HISTORIC AND DESIGN REVIEW COMMISSION

November 06, 2019

HDRC CASE NO: 2019-615 403 N HACKBERRY ST **ADDRESS:** NCB 576 (929 E CROCKETT), BLOCK 15B LOT 14 **LEGAL DESCRIPTION: ZONING:** R-3, H **CITY COUNCIL DIST.:** 2 **Dignowity Hill Historic District DISTRICT:** Mario Crosswell/CCP Premier Investments LLC **APPLICANT:** San Antonio San Antonio/CCP PREMIER INVESTMENTS LLC **OWNER: TYPE OF WORK:** Front vard fence September 25, 2019 **APPLICATION RECEIVED: 60-DAY REVIEW:** November 24, 2019 Huy Pham **CASE MANAGER:**

The applicant is request a Certificate of Appropriateness for approval to construct a 5-foot-tall privacy fence flush to the front façade plane and intersecting the wraparound porch.

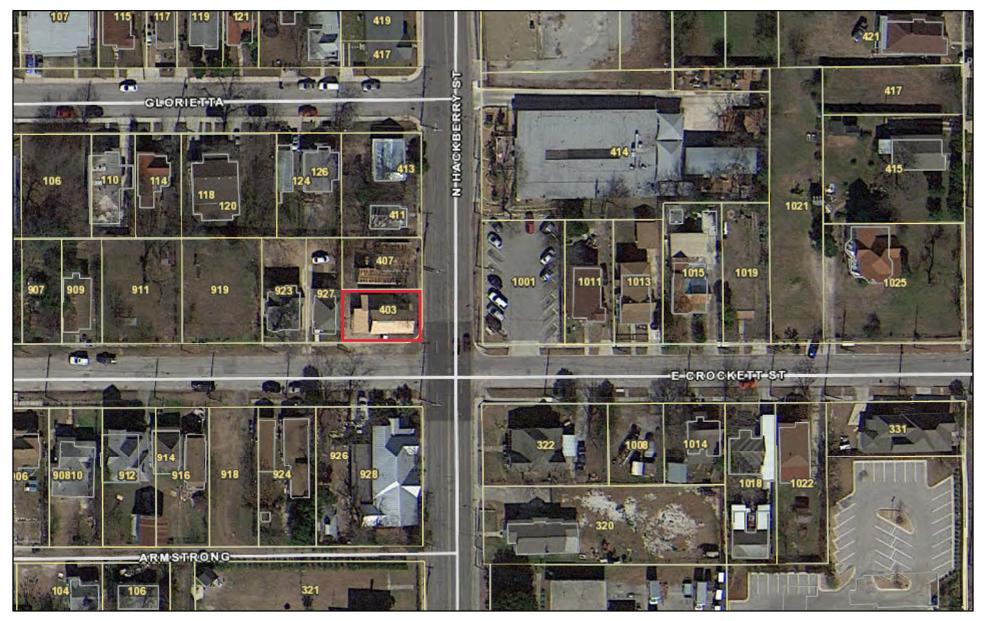
- c. FENCE DESIGN The applicant has proposed to install a 5 foot tall solid wood privacy fence to enclose the side porch which is connected to the front porch. Per the Guidelines for Site Elements 5.B.i., new fences and walls should appear similar to those used historically within the district in terms of their scale, transparency, and character; design of fences should respond to the design and materials of the house or main structure. Per the Guidelines for Site Elements 5.C.i., privacy fences should be set back from the front façade of the building, rather than aligning them with the front façade of the structure to reduce their visual prominence. Staff finds that privacy fences of that style and height are not found in the front yard nor bisecting wraparound porches and should be avoided.

- d. FENCE LOCATION The applicant has proposed to install a 5 foot tall solid wood privacy fence perpendicular to the front façade plane to enclose the side porch which is connected to the front porch. Per the Guidelines for Site Elements 5.B.ii., applicants should avoid installing a fence or wall in a location where one did not historically exist, particularly within the front yard. The appropriateness of a front yard fence or wall is dependent on conditions within a specific historic district. Additionally, new front yard fences or walls should not be introduced within historic districts that have not historically had them. Side and rear fences set behind the front façade plane are found throughout the historic district. However, staff finds that privacy fences of that style and height are not found in front yards nor do they bisect wraparound porches, and should be avoided.

- e. FENCE HEIGHT –The applicant has proposed to install a 5 foot tall solid wood privacy fence perpendicular to the front façade plane to enclose the side porch which is connected to the front porch. Per the Guidelines for Site Elements 5.B.iii., applicants limit the height of new fences and walls within the front yard to a maximum height of four feet. Solid fences, if approved, are allowed 3 feet in the front yard and 6 feet in the rear yard. Staff finds the rear yard for this property is defined be the second front-facing façade plane because of the wraparound front porch configuration. The solid privacy fence should be set to rear at its current height.

Staff does not recommend approval of the proposed fencing as installed based on finding b through e. A solid privacy fence may be approved administrative if it is set in the rear yard, which for this property is defined by the second front-facing façade plane.
